September 8, 2020 (revised 4/6/21)

SUBJECT: AMENDMENT NO. 1 (Revised) - Otay Mesa Central Village Lumina Development On-Site Sewer Study (Tentative Map No. 1972222 | PTS No. 555609)

Amendment No. 1 Revised

FIGURE 2

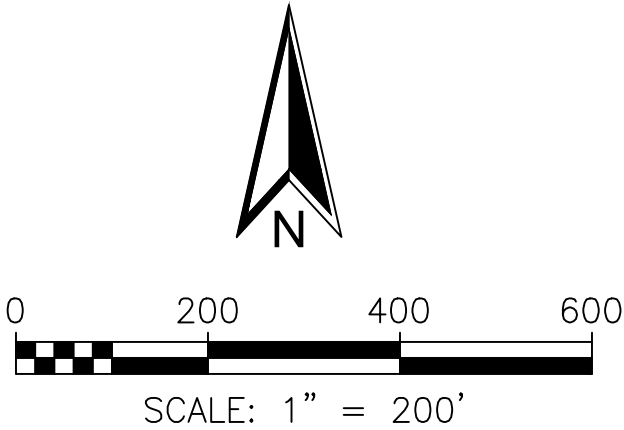
1. *The sewer exhibit should be size 24"x36" labeled all proposed developments.*
2. *On the sewer study exhibit, clearly show and label the proposed sewer laterals from the proposed developments to the point of connection to the existing public mains. (revised 4/6/21)*

1. The sewer exhibit should be size 24"x36" labeled all proposed developments.
2. On the sewer study exhibit, clearly show and label the proposed sewer laterals from the proposed developments to the point of connection to the existing public mains.
3. The sewer calculations table should be revised accordingly.

In response to this request Amendment No 1 Revised includes an updated sewer exhibit with all proposed developments labeled, and sewer lateral locations shown for each lot(s). The hydraulic calculations have been revised and reflect the final sewer design improvements being prepared by PDC. Based on the analysis, there were no changes to sewer pipe diameters and all City Sewer Design Criteria continues to be satisfied.
